Template for comments and secretariat observations

Date: 2015-10-27	Document: EN 1493:2010	Project: Revision
------------------	------------------------	-------------------

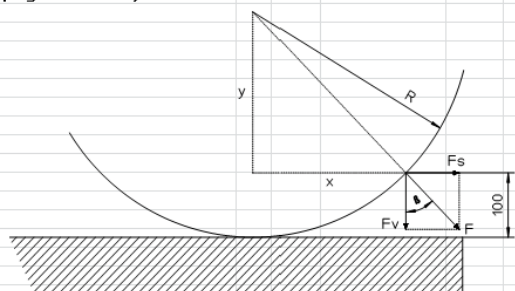
48)	NL	5.9.6		te / ed	Roll off safety The text in paragraph 5.9.6 states that a horizontal force of 20% of the rated load has to be applied to the top of <i>each</i> end stop, without causing permanent deformation. To our opinion this 20% on each end stop is too much. The original calculations of Stertil showed a total horizontal stopping force of 19% of rated capacity for a 12 ton vehicle lift. In these calculations, <i>no</i> rolling resistance was included. Calculations of Maha showed 5% of rated load for a 5 ton rated capacity lift, but <i>with</i> rolling resistance. 1) The wording end stop is probably not clear enough. "End stop" can point to the total of stopping means at one end of the lift. It also can be defined as a single stop at the end of one runway. In the calculations of course the total is meant, as it also relates to the rated capacity of the lift as a whole. Therefore a better	1) Refer to "end stop" as <i>the total of stopping means at one end of the lift</i> . Or define end stop as <i>a stopping device at the end of one runway</i> . 2) The stopping force should be defined as maximum 20% of rated capacity applied to the total of stopping devices at one end of the lift, or 10% on each end stop at the end of one runway. 3) The load on the end stop should not only be defined as a horizontal force. Maybe it is better to refer to it as a horizontal <i>resultant</i> force, which leaves the possibility to bring the other (resultant) forces into account.

No.	MB/ NC ¹	Clause/ Subclause (e.g. 3.1)	Paragraph/ Figure/ Table/ (e.g. Table 1)	Type of comment ²	Comments	Proposed change	Observations of the secretariat
					<p>wording has to be found.</p> <p>2) Steril made new calculations (see Excel file), differentiated for the first 6 normative vehicles (a through f). These normative vehicles have different wheelbases, which, in combination with vehicle lifts with suitable runway lengths, results in different free distances that allow a vehicle to develop speed. This effect is limited with normative vehicles g through l, because in most cases they just fit on a lift. Furthermore these vehicles have different wheel sizes, which give different angles at which the radial force is working. In the new calculations, also the rolling resistance is included, the stopping time is reduced from 1 second to the 0,8 second that Maha used in their calculation. This all results in total horizontal stopping forces from 8% to max 16% of rated capacity. Also a check is done on the height of the end stop: it should prevent the vehicle from driving over it. This is proven by the vertical resultant force that has to be smaller than the smallest axle load.</p> <p>3) The expression 'horizontal force' needs to be changed. Since this horizontal force is a <i>resultant</i> of the radial force, it never works without the, also resultant, vertical force (see calculation in Excel</p>

No.	MB/ NC ¹	Clause/ Subclause (e.g. 3.1)	Paragraph/ Figure/ Table/ (e.g. Table 1)	Type of comment ²	Comments	Proposed change	Observations of the secretariat
					file). When designing end stops, these forces are taken into account. Therefore the wording that is used to describe the load on the end stop should be changed as well.
